FURLOW CHARTER SCHOOL

Modular Building Site Work IFB - Questions & Answers

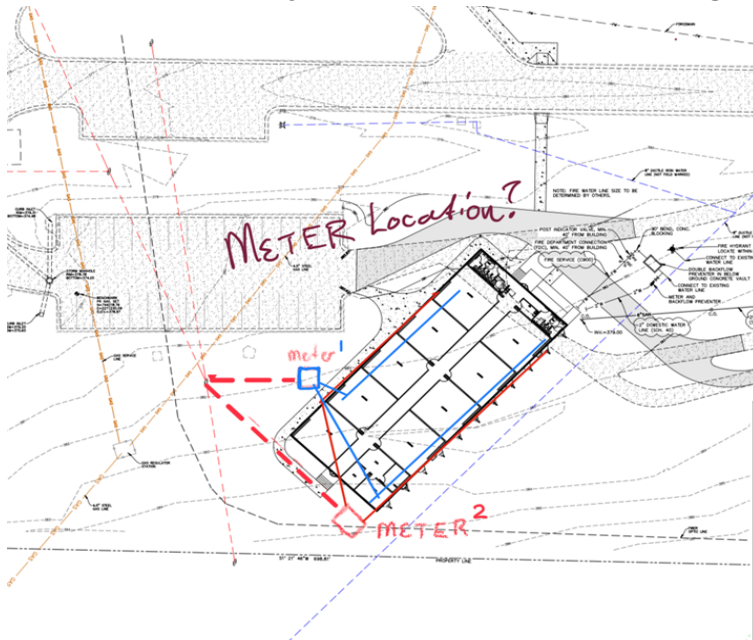
Meter location for Power. See below. GP will have the final decision on the power run but given the option would you want the power run underground or overhead?

No preference.
